Addendum: **2**

Date: **5/13/2025**

Project: **FWCS HPB Natatorium HVAC Improvements**

Comm #: **24634**

Item #3: Drawing Sheet A201, "Demolition Plan, Floor Plan, Window Elevation Detail, & Notes."

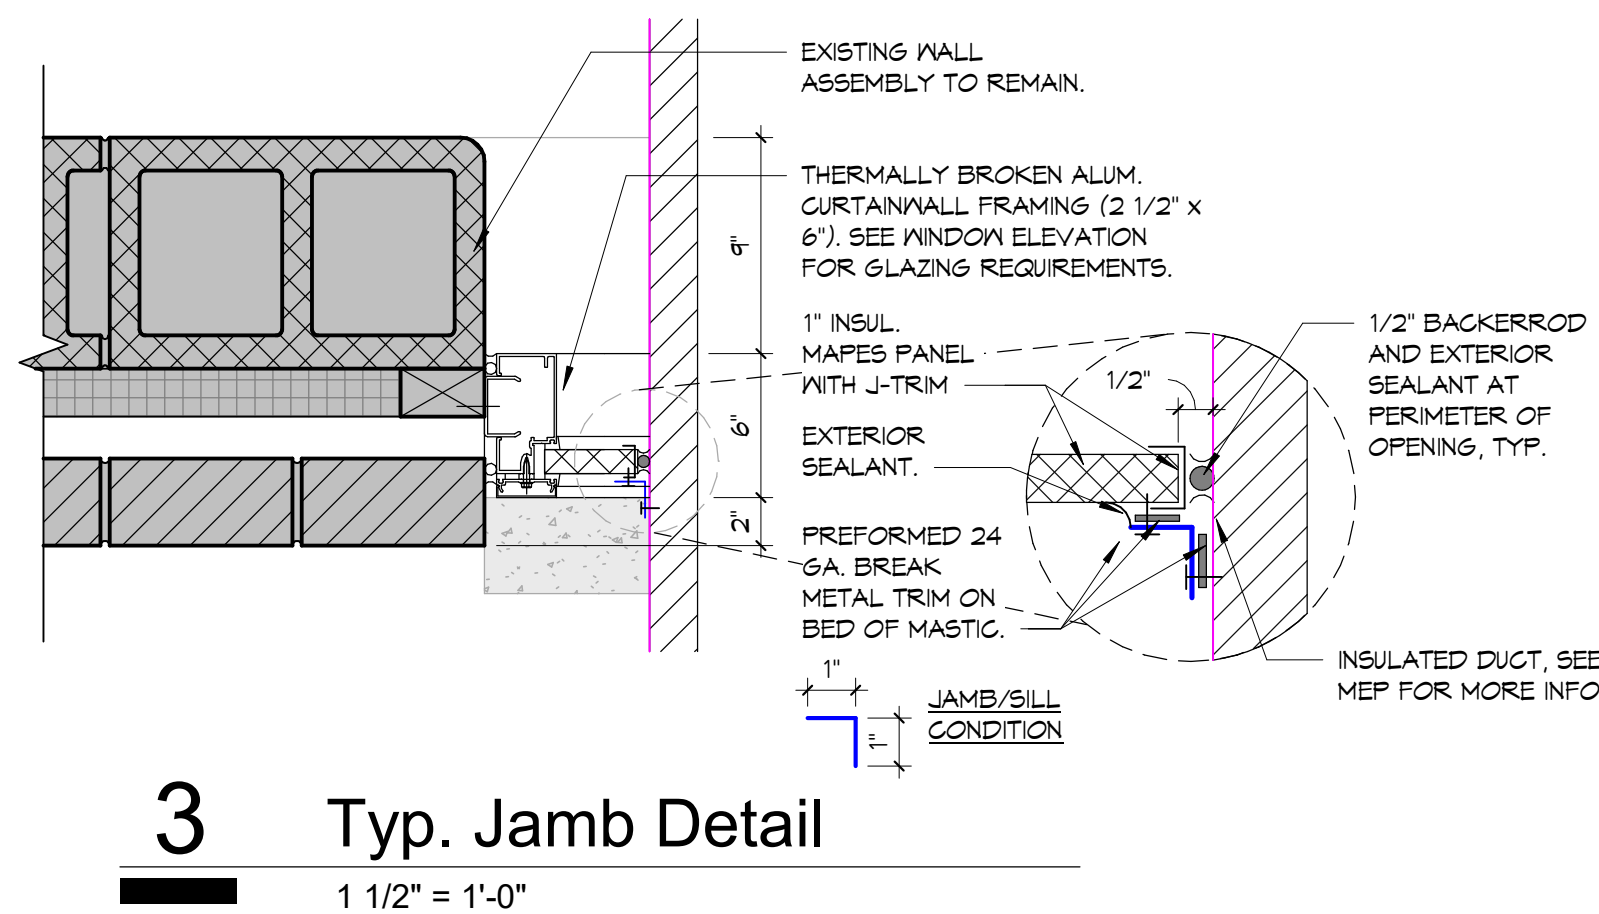
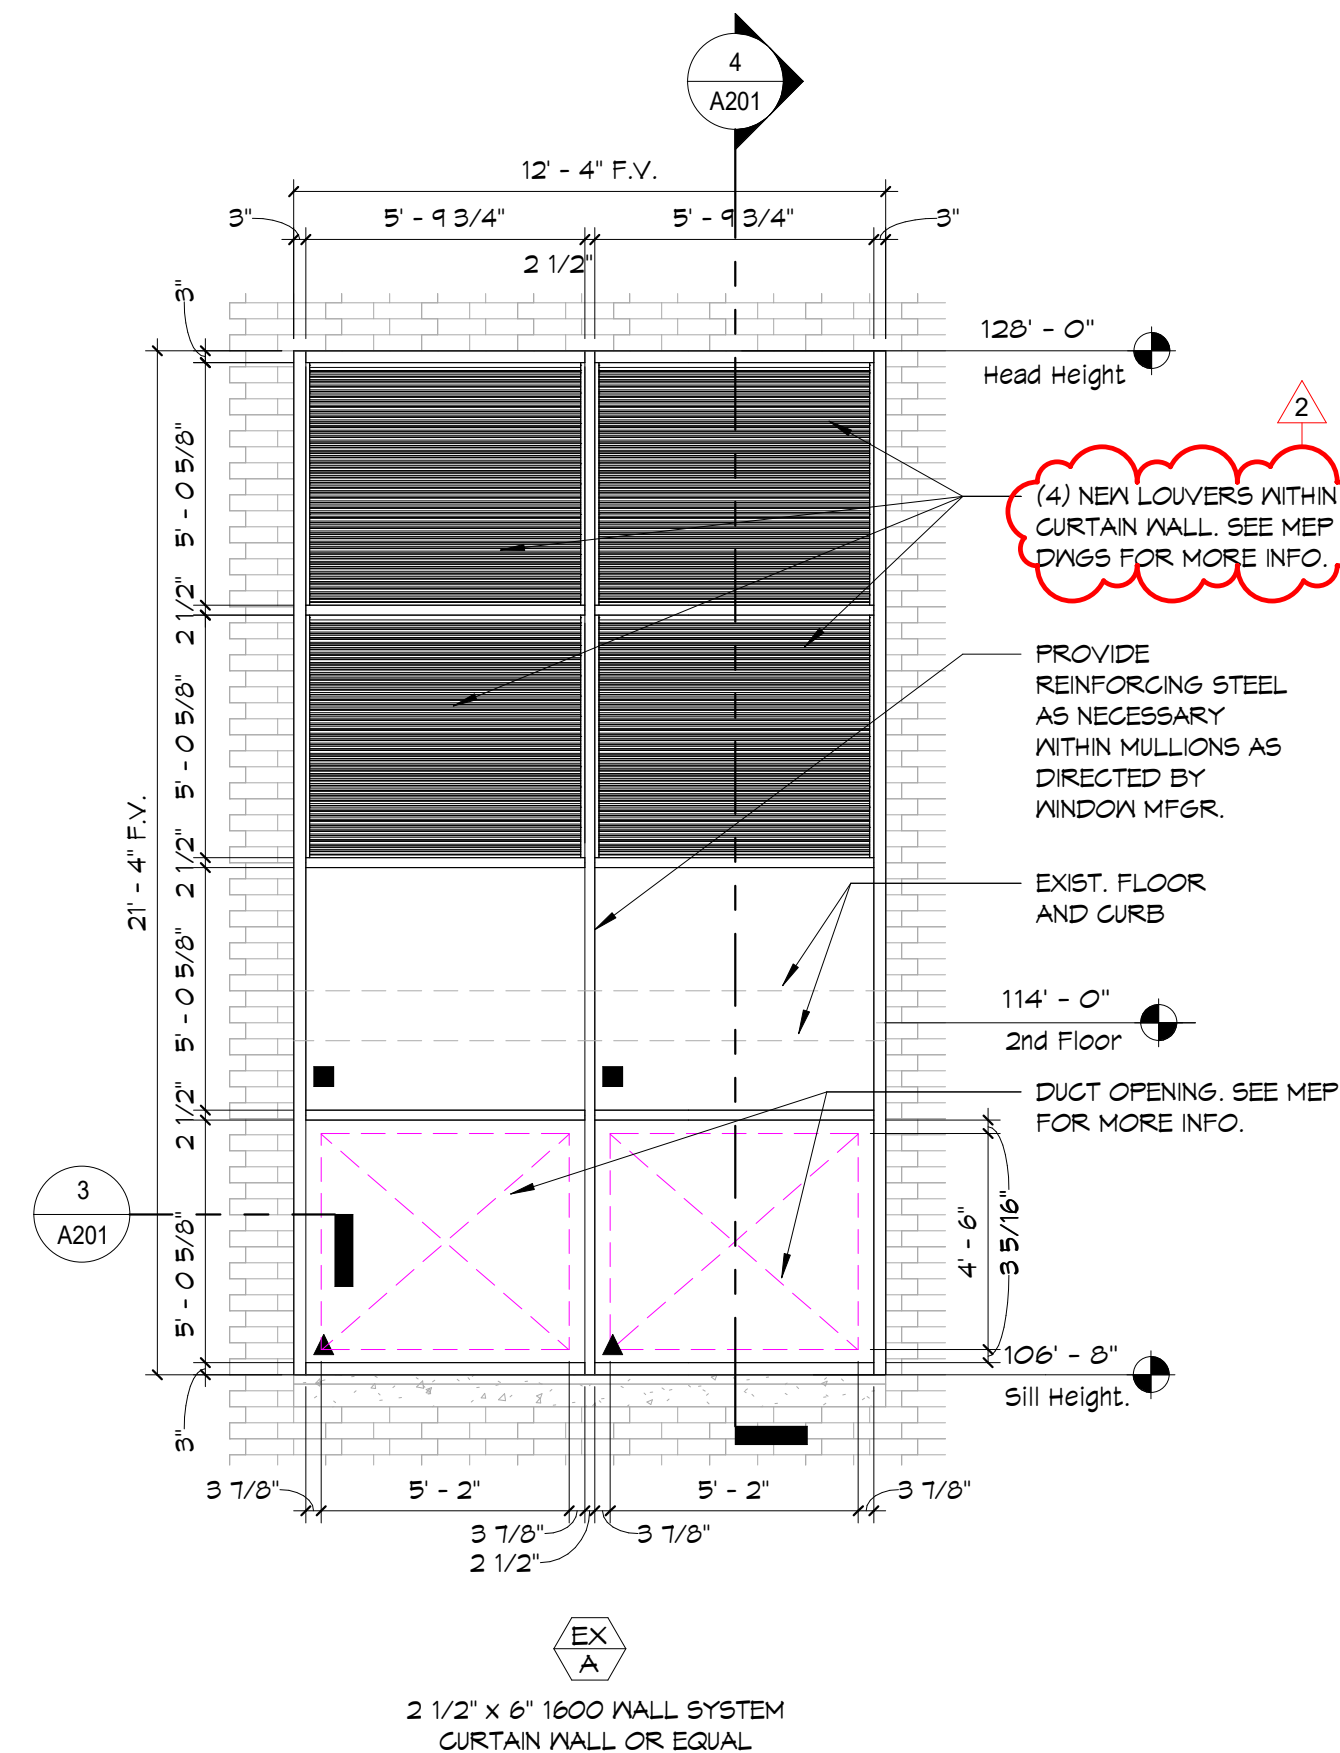
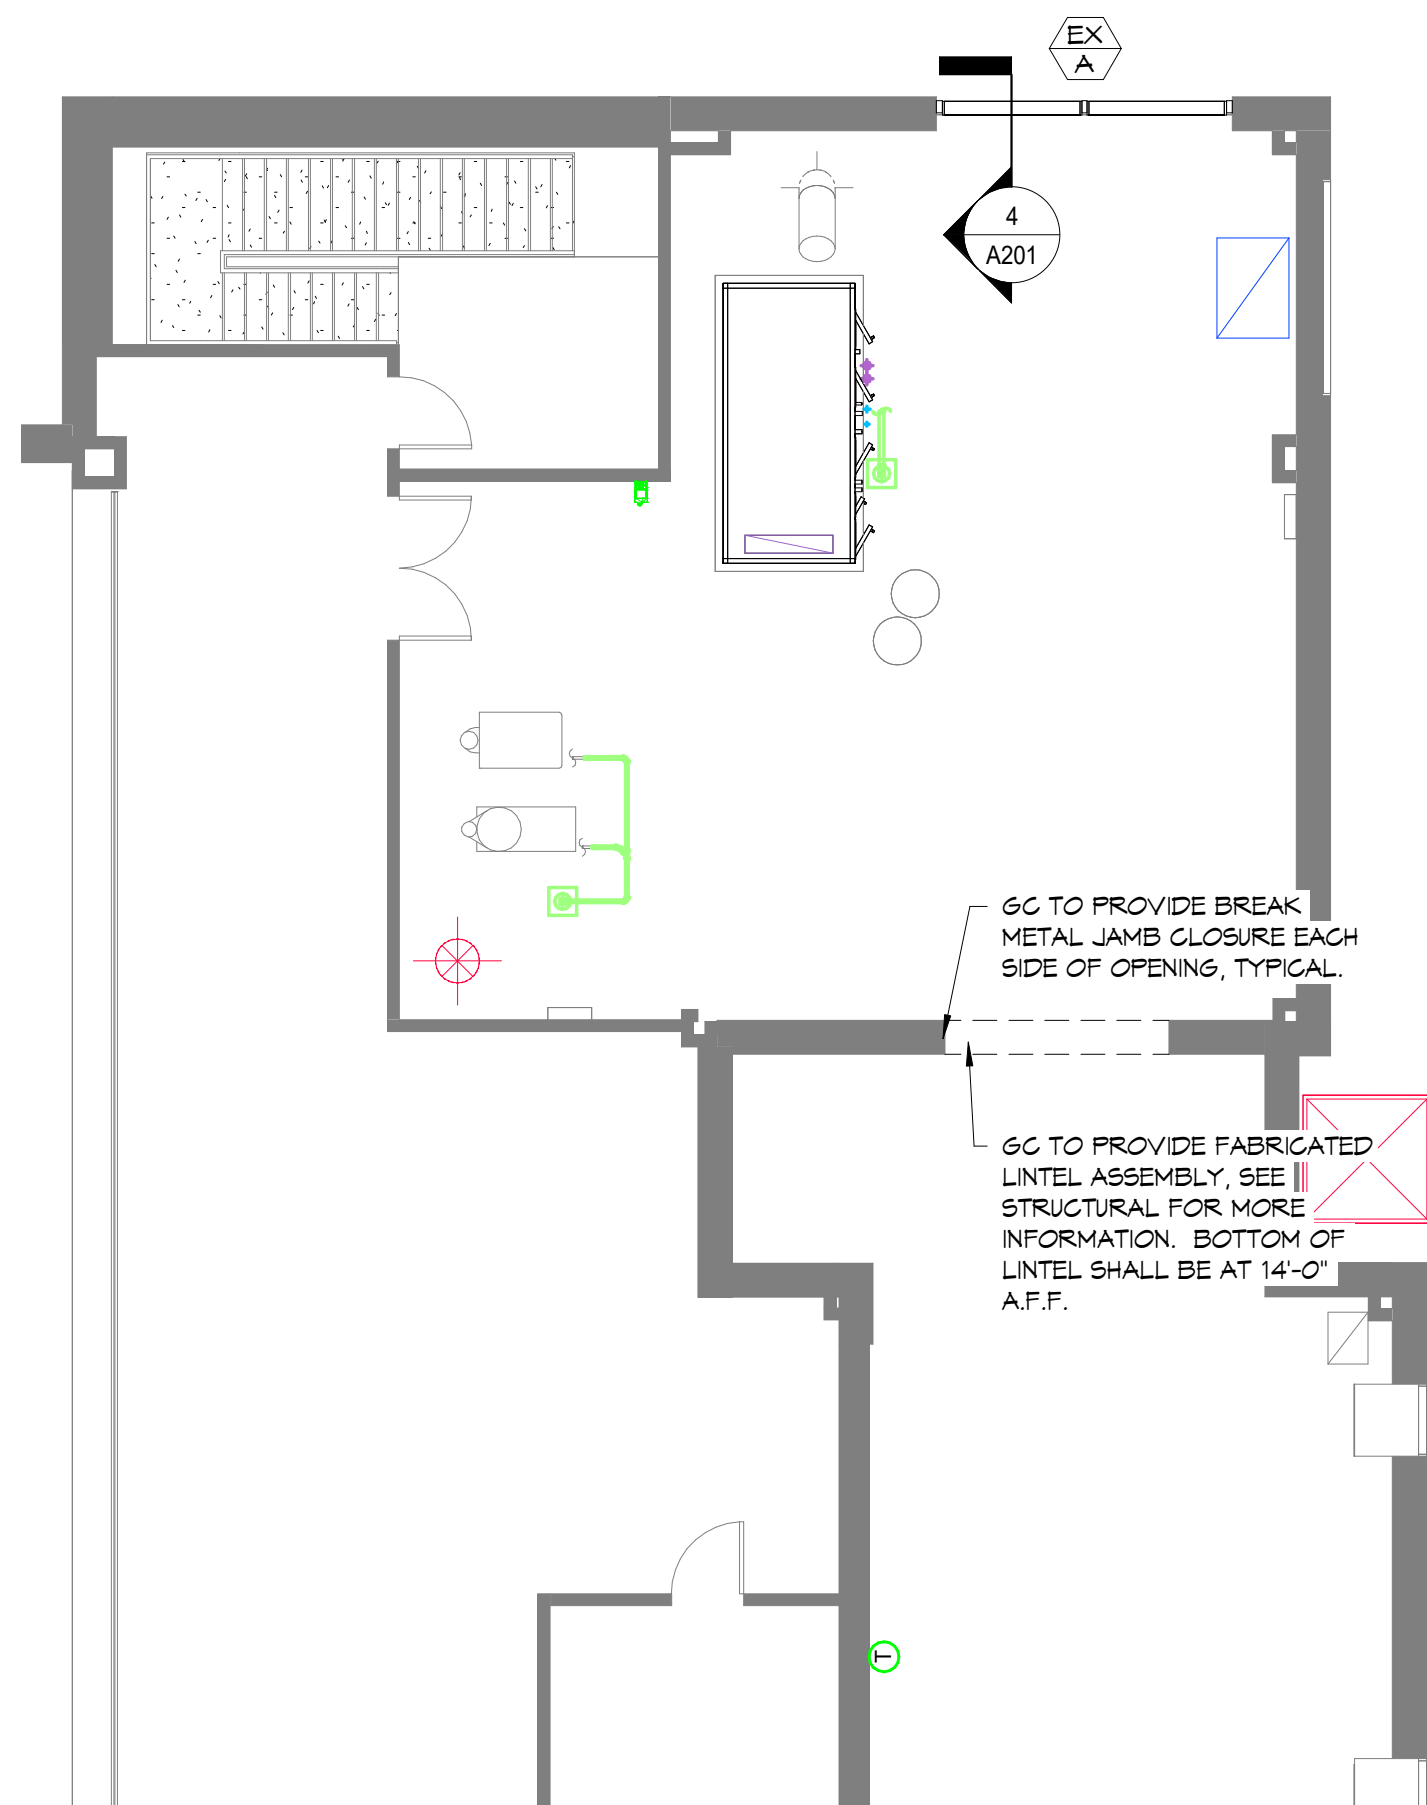
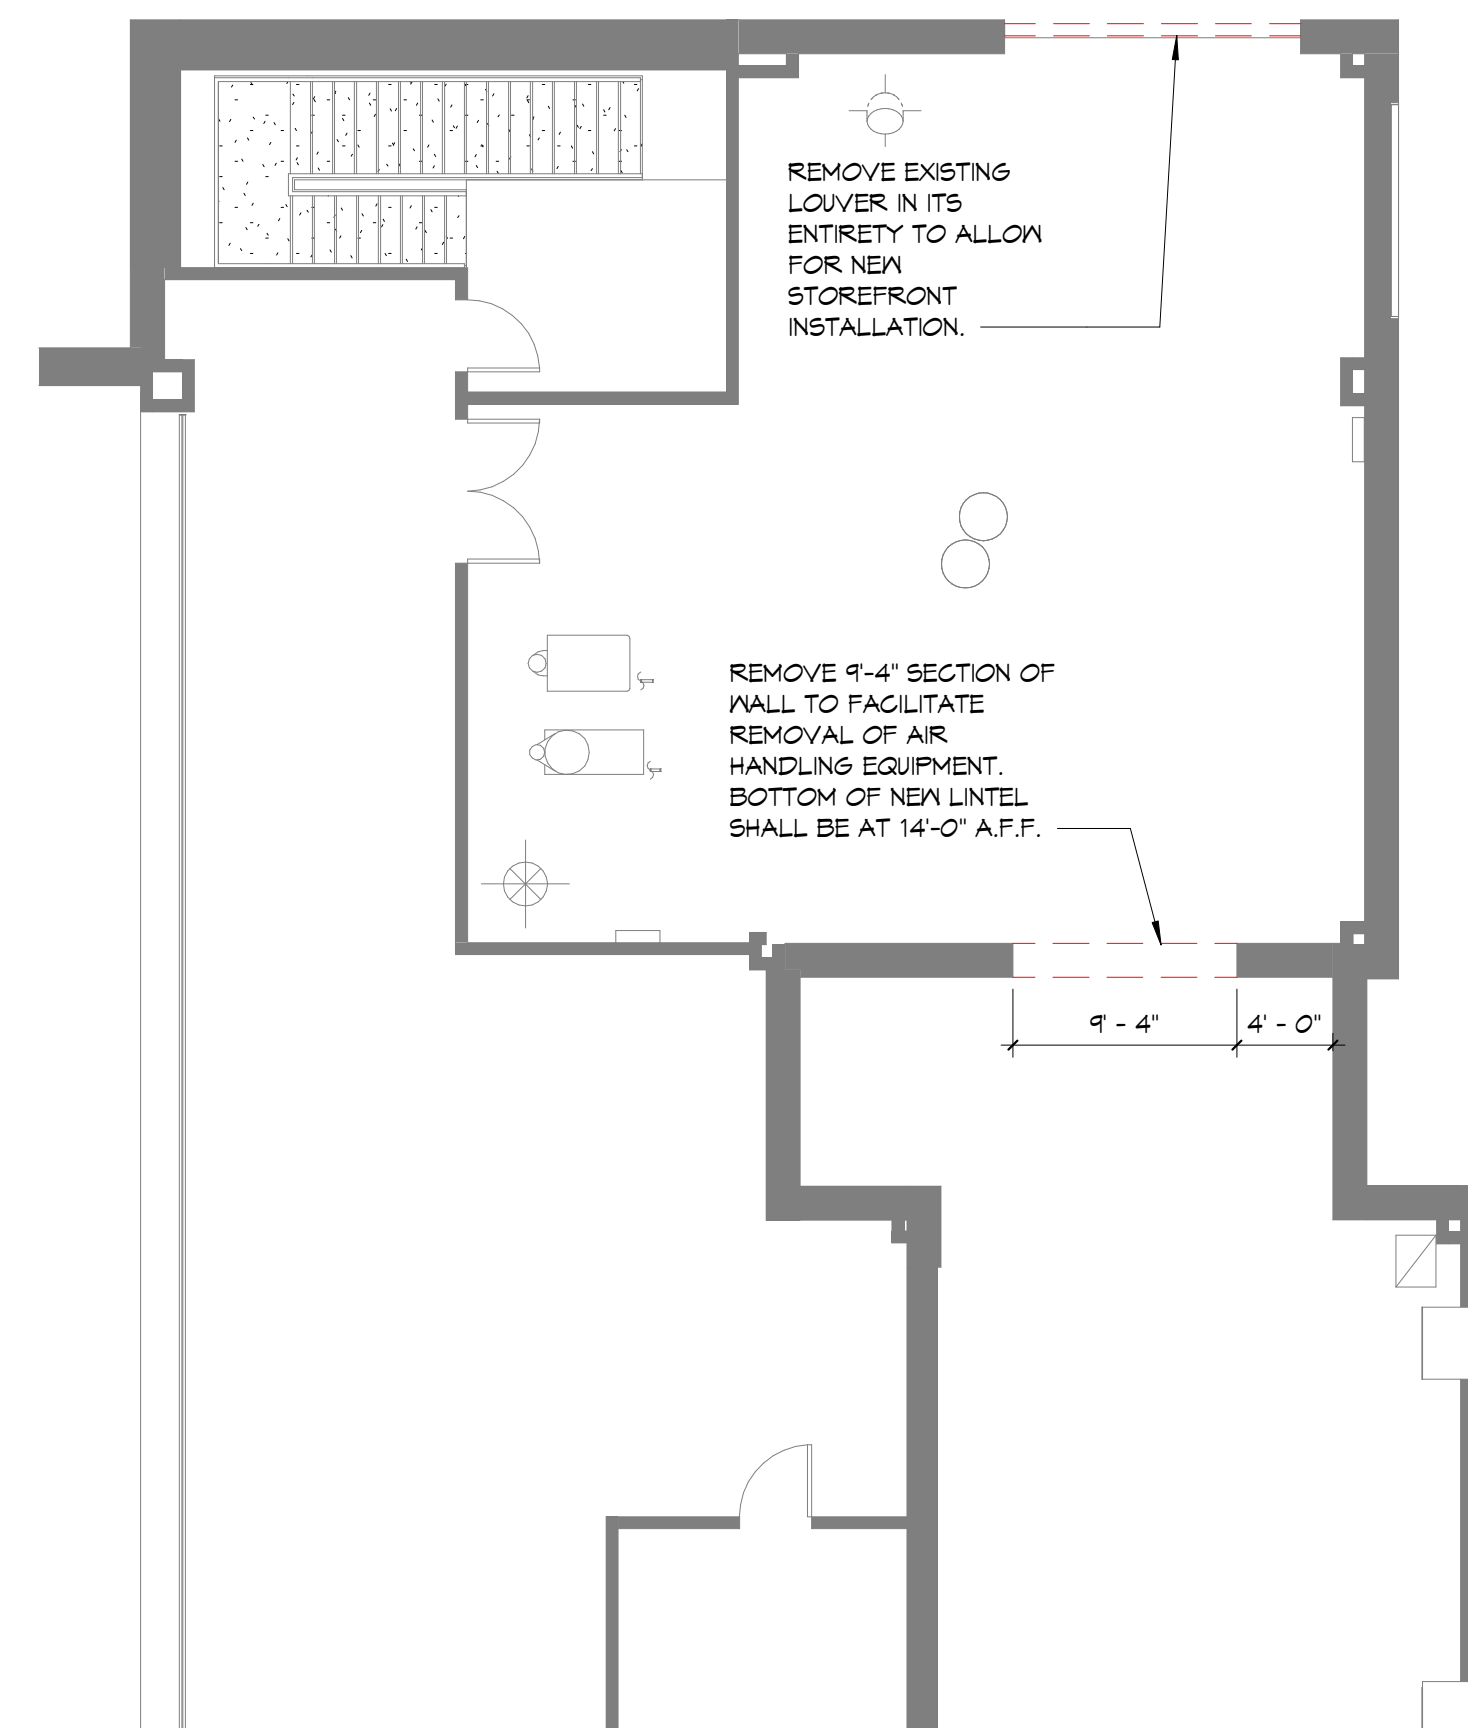
- A.** Revise glazing details. Refer to attached drawing revision dated 5/13/2025.
